ECE/TRANS/WP.29/GRE/2009/4/Rev.1
31 March 2009

REGULATION No. 53
(Installation of lighting and light-signalling devices for L₃ category of vehicles)

Visibility of adaptive front-lighting systems (AFS) for motorcycles and glare

Proposal for Supplement 11 to the 01 series of amendments to Regulation No. 53

EXPLANATION ABOUT "THE HORIZONTAL INCLINATION", "THE BANK ANGLE"
AND THE ANGLE " δ ".

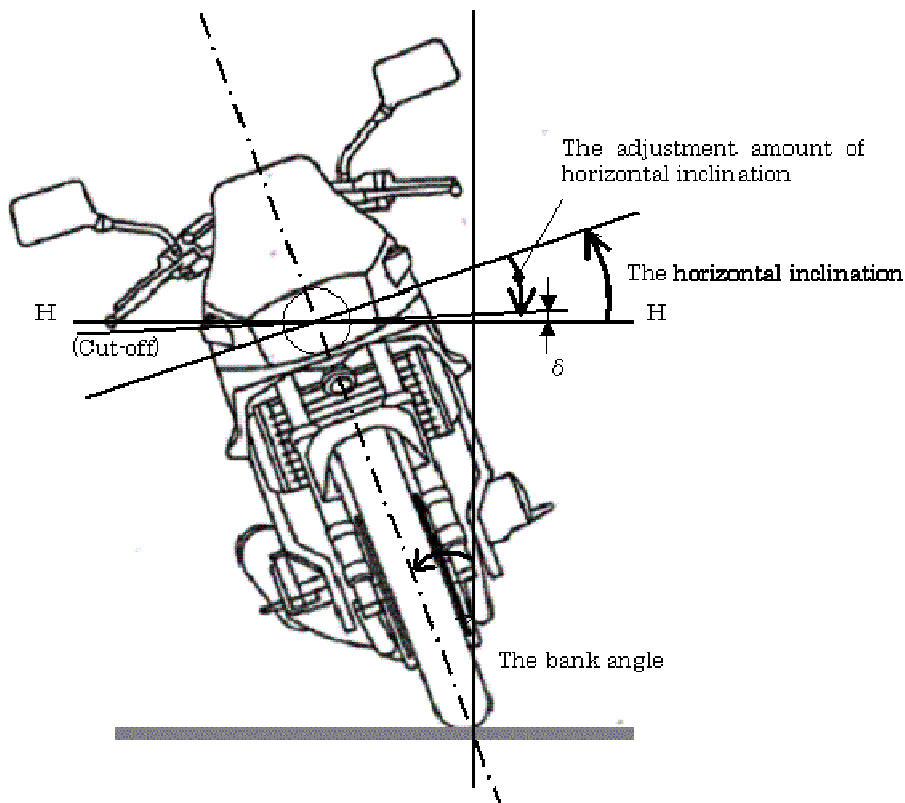
2.24. "Horizontal inclination" means the angle created between the beam pattern when the motorcycle is set as specified in paragraph 5.4., and the beam pattern when the motorcycle is banked (see drawing in Annex 6).

2.26. "Bank angle" means: the angle made with the vertical by the vertical longitudinal median plane of the motorcycle, when the motorcycle is rotated about its longitudinal axis (see drawing in Annex 6).

2.29. "HIAS test angle" means the angle δ created by the headlamp cut-off line and HH line (in case of an asymmetrical beam headlamp, the horizontal part of the cut-off shall be used), (see drawing in Annex 6)

Insert a new Annex 6, to read:

Figure 1. Description of the Function of the Inclination Angle adjustment-Type AFS

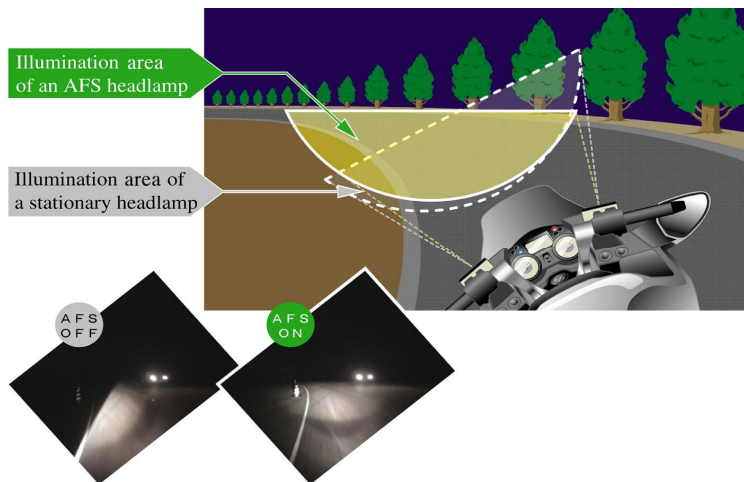
This proposal specifies the requirements concerning the vehicle's horizontal inclination angle adjustment-type headlamps installed on motorcycles.

In the case of a motorcycle, due to its driving characteristics, the headlamp inclines with the vehicle when the vehicle is running on a curved road, narrowing the illumination area of the headlamp in the travelling direction. Therefore, by adjusting the variation of the headlamp's light distribution from that when the vehicle is upright (i.e.: in the standard condition), to keep the illumination area wide enough, the visibility is expected to improve.
